**RESPONSE TO ACTION ITEMS FROM PUBLIC MEETINGS BETWEEN  
NRC AND DOE TO DISCUSS RAI FOR THE  
SAVANNAH RIVER SITE**

September 2005

**Westinghouse Savannah River Company  
Closure Business Unit  
Planning Integration & Technology Department  
Aiken, SC 29808**

Figure 6-1. Annual Infiltration as a Function of Annual Precipitation

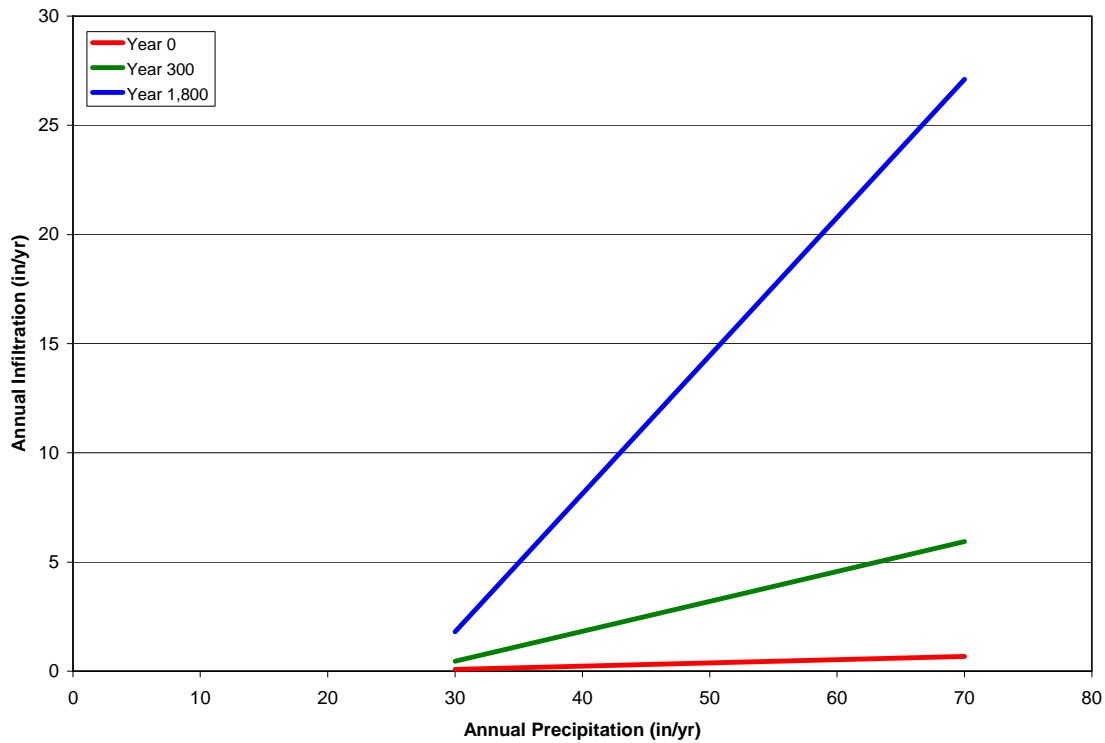
Provide root depth for pine trees and possible impacts on cap performance (e.g., fast pathways) (RAI 24)

Based upon these conservative assumptions, the range of annual infiltration that could result from annual precipitation ranging from approximately 30 to 70 inches/year has been determined for years 0, 300, and 1,800 which were previously modeled (Phifer and Nelson 2003; Section 6.2, Phifer 2003; Section 5.2). At year 0, the closure cap is intact; at year 300, holes have begun to form through the upper GCL; and, at year 1,800 and beyond, the upper GCL has essentially failed hydraulically. Figure 6-1 provides plots of annual infiltration over an annual precipitation range of 30 to 70 inches/year for years 0, 300, and 1,800, and Table 6-1 provides the statistics for the data upon which the Figure 6-1 plots are based along with the percentage of holes through the upper GCL at the given time. Additional information regarding the generation of these ranges

At year 0, with no holes through the upper GCL, infiltration through the upper GCL ranges from 0.13 to 0.73 with an average of 0.36 inches/year due to 30 to 70 inches of precipitation per year (see Table 6-1). At year 300, with holes in only 0.018 percent of the upper GCL, infiltration through the upper GCL ranges from 0.88 to 6.52 with an average of 3.0 inches/year due to this precipitation range (see Table 6-1). At year 1,800, the upper GCL has essentially failed hydraulically with holes only in 0.29 percent of the upper GCL, resulting in infiltration through the upper GCL ranging from 3.1 to 30.6 with an average of 13.8 inches/year due to this precipitation range (see Table 6-1). As seen, significant increases in annual infiltration through the upper GCL develop rapidly with the presence of very few holes in the upper GCL.

Figure 9-1. Comparison of technetium vs. nitrate leaching from slag- and cement based saltstone lysimeters (MMES 1992)

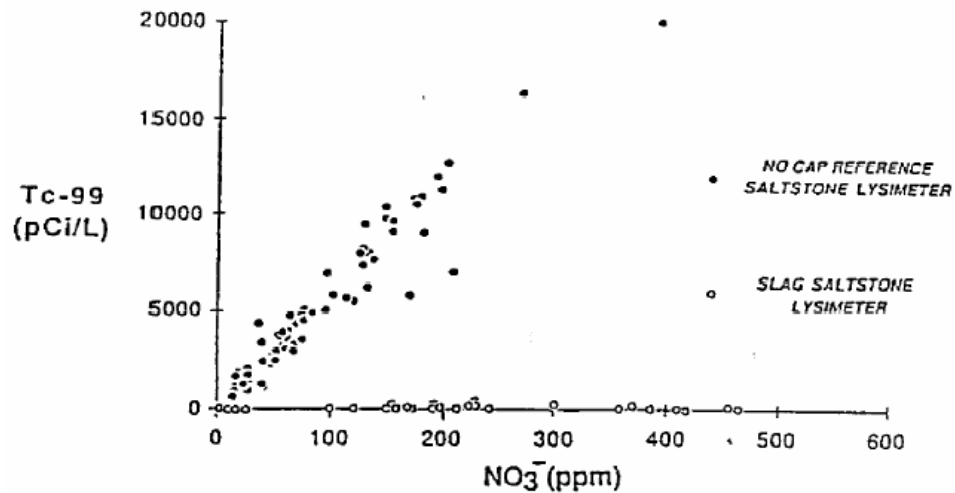
Provide any additional information to support reducing conditions of the saltstone wasteform considering cracking and oxygen transport in the gas phase (RAI 41, 55).

More compelling evidence in support of the contention that slag saltstone maintains a reducing environment is presented in Figure 9-1 from the 1992 Performance Assessment (MMES 1992; page 2-54). As shown in the figure, no Tc-99 leached for 2.5 years from a field lysimeter containing slag saltstone (open circles), but did leach from a lysimeter containing saltstone without slag (filled circles).

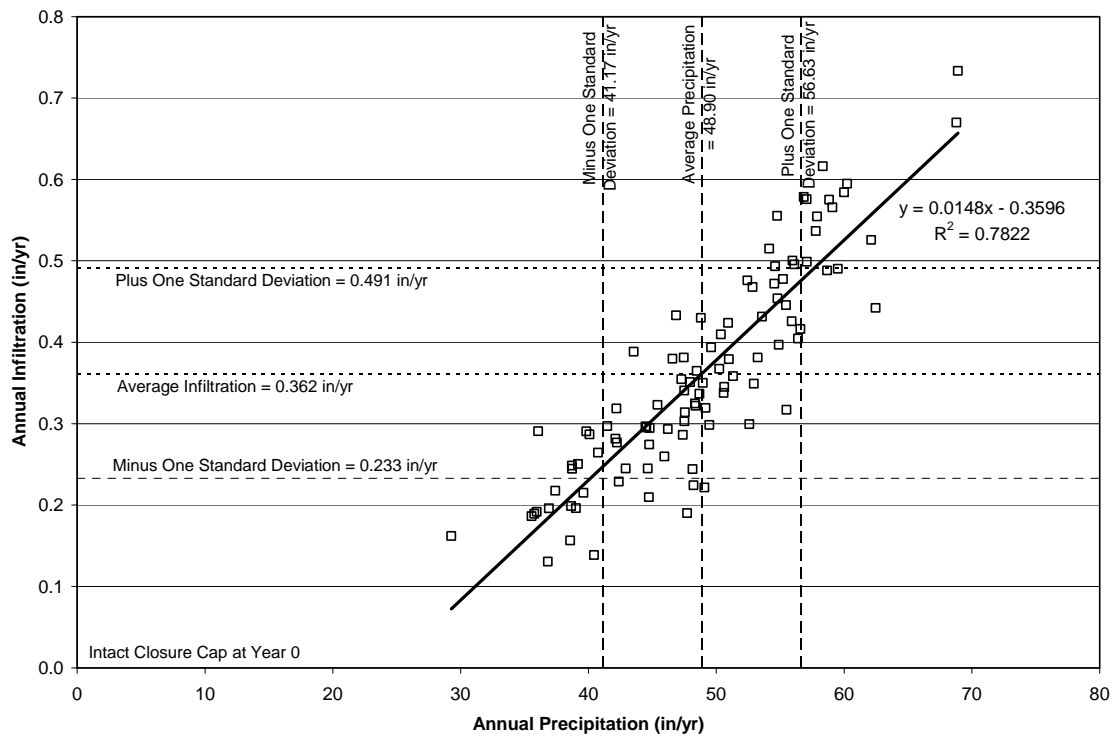
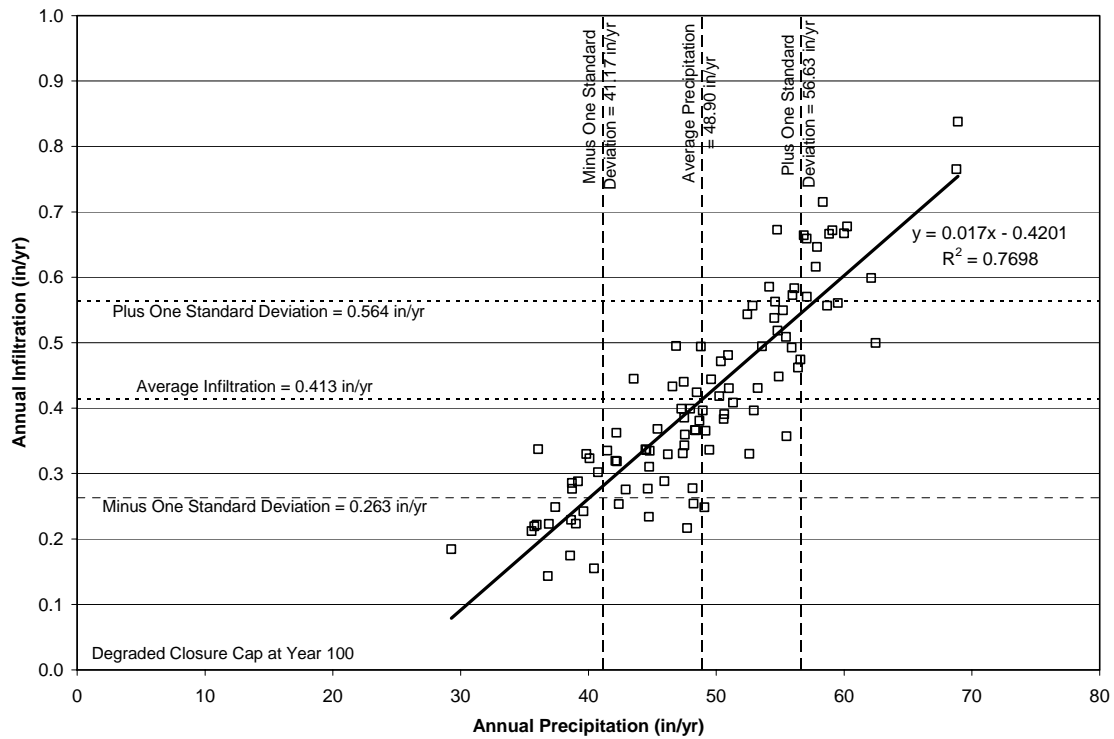
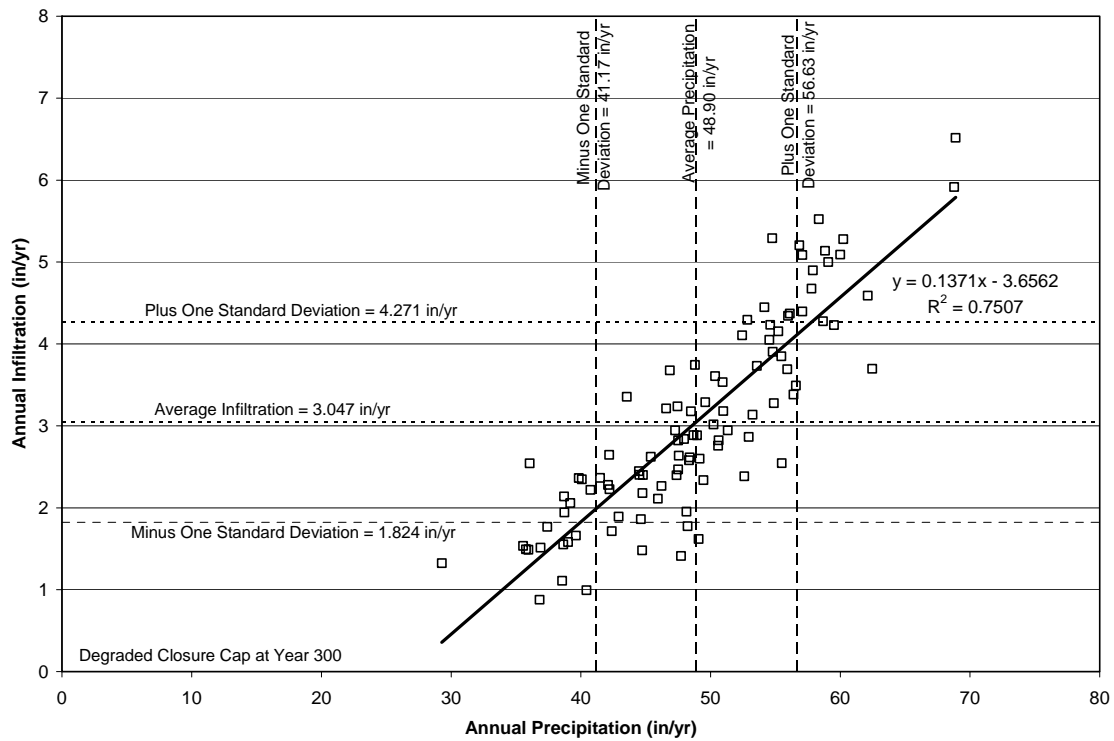
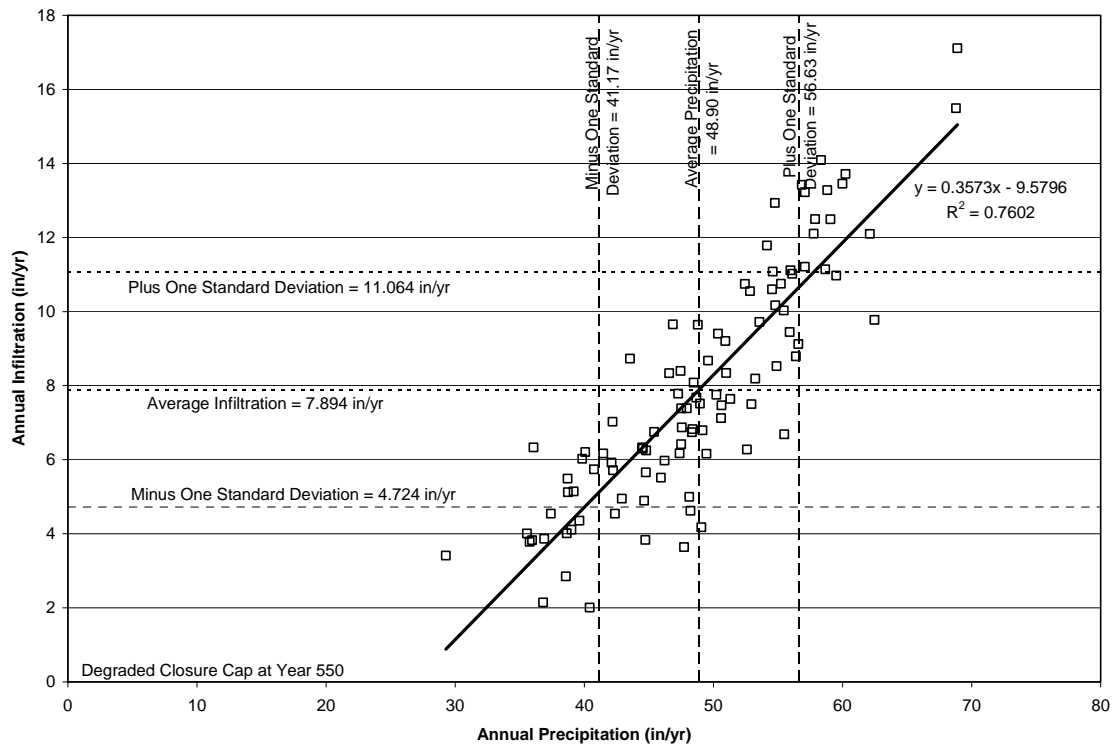
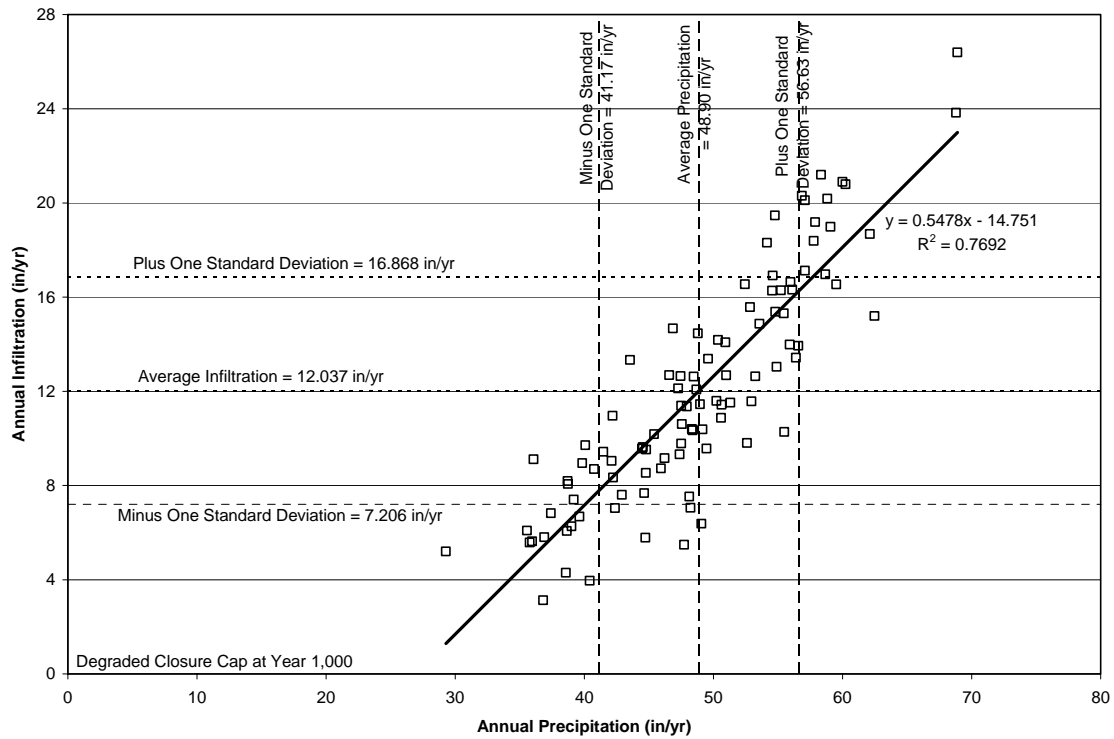
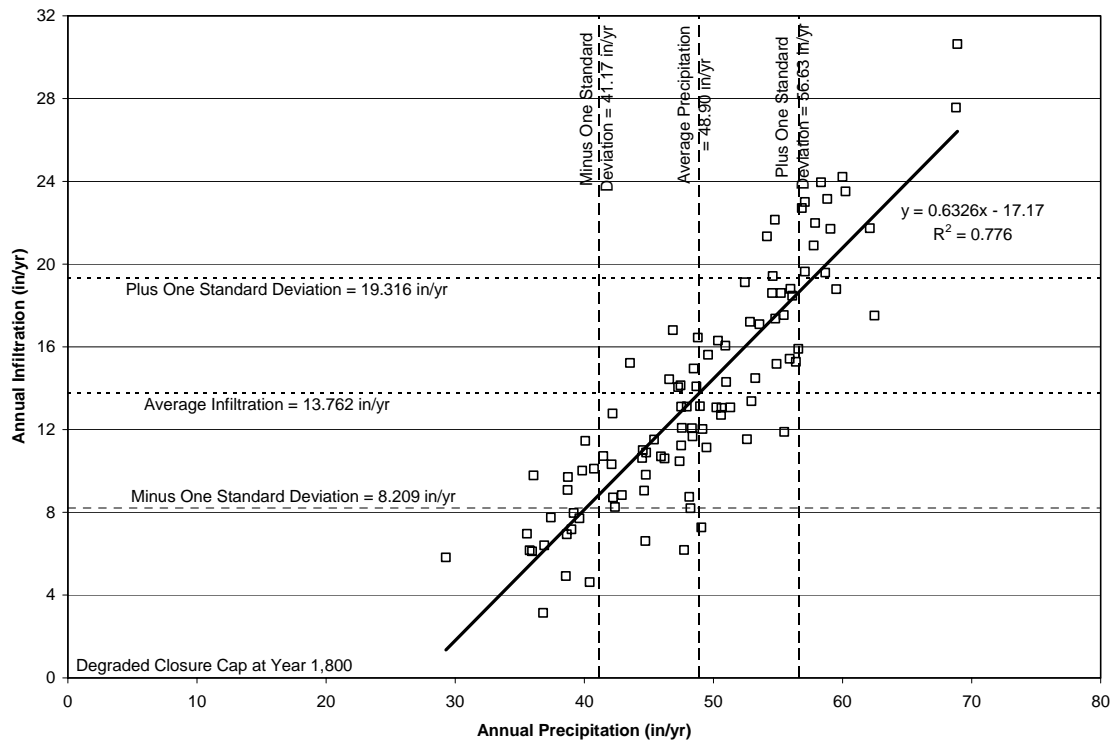
Provide information on the range of precipitation and infiltration rates with regard to the cap (RAI 20).

Figures 12-2 through 12-10 provide the potential range of annual infiltration through the upper GCL resulting from 30 to 70 inches/year of annual precipitation for each year modeled (i.e., 0, 100, 300, 550, 1,000, 1,800, 3,400, 5,600, and 10,000). Table 12-2 provides the statistics associated with the precipitation and infiltration data. Table 12-3 provides the best fit linear regression equation and the associated coefficient of determination,  $R^2$ , for annual infiltration through the upper GCL as a function of annual precipitation for each year modeled. Figure 12-11 provides plots of annual infiltration as determined from the associated linear regression equations over an annual precipitation range of 30 to 70 inches/year for each year modeled.

As shown by this data, infiltration through the upper GCL ranges from 0.13 to 0.73 inches/year with an average of 0.36 inches/year due to 30 to 70 inches of precipitation per year (see Table 12-2), with the initial conditions of the upper GCL and upper drainage layer. However, as the upper GCL and upper drainage layer degrade, the range of infiltration produced by this precipitation range increases (see Figures 12-1 thru 12-10 and Figure 12-11). At year 1,800, the upper GCL and upper drainage layer have essentially failed hydraulically and infiltration through the upper GCL ranges from 3.1 to 30.6 inches per year with an average of 13.8 inches/year due to this precipitation range (see Table 12-2).

Figure 13-1.

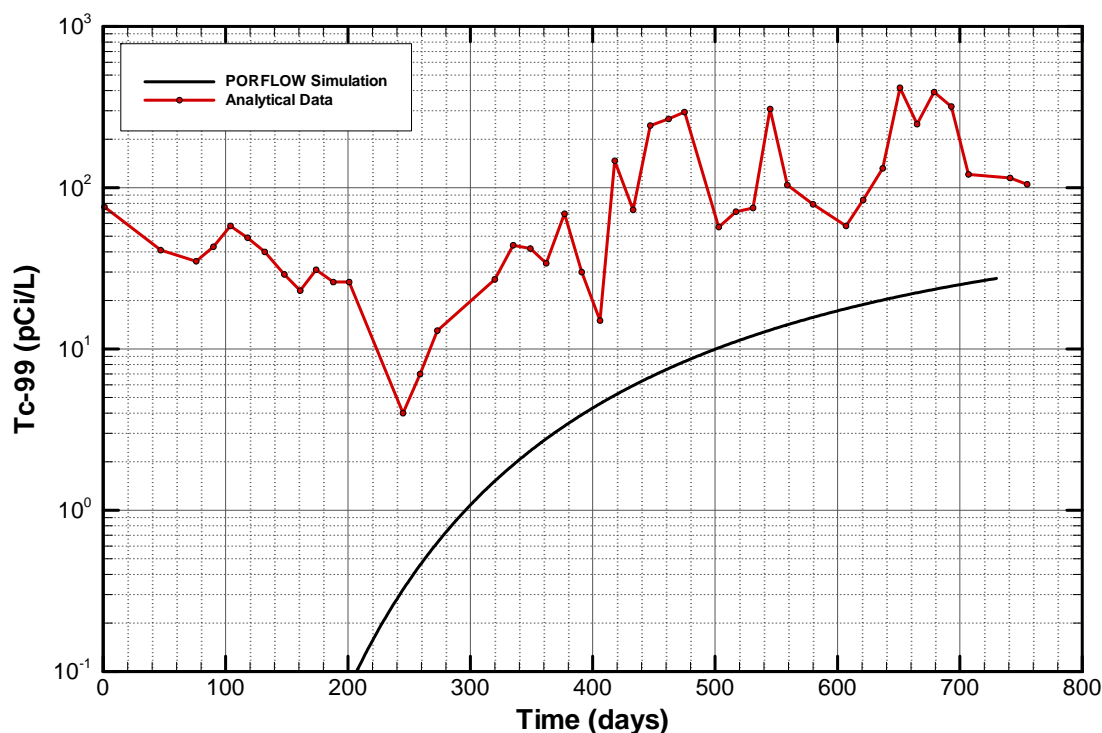
Provide a comparison of the slag data on a non-linear scale or in tabular form (RAI 31).

**SRS Response:** Figure 13-1 below presents the data from the Saltstone Slag lysimeter and the PORFLOW simulation of the slag lysimeter on an expanded scale. The plot shows that the results of the PORFLOW simulation are less than the slag lysimeter results. This is because the measurements from the saltstone lysimeters were not specific for Tc-99. Rather, the measurements were for gross non-volatile beta-gamma emitters (i.e., the sample was evaporated onto a planchet and counted without energy discrimination). The results shown are essentially background, which is consistent with the PORFLOW simulation.

Figure 18-1:

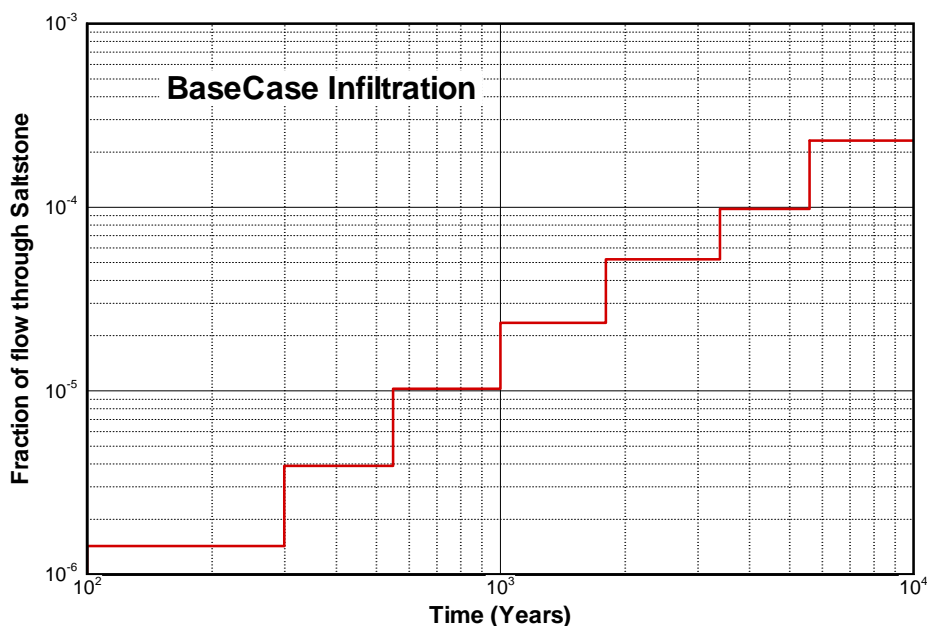
Provide information regarding concentration fluxes of NO<sub>3</sub> in the vault area (RAI 45, 46).

**SRS Response:** In discussions during the public meeting between the U. S. Nuclear Regulatory Commission and the U. S. Department of Energy on July 27, 2005, two questions were raised regarding this topic. The first question requested information to define the fraction of the water reaching the vault that traveled through the vault versus the fraction that flowed around the vault. Figure 18-1 below plots the fraction of the infiltration reaching the vault that enters the vault system for the base case in the 2005 Special Analysis (Cook et al. 2005). The fraction ranges from about 1E-6 at 100 years to about 2E-4 at 10,000 years. The remaining water flows around the vault.
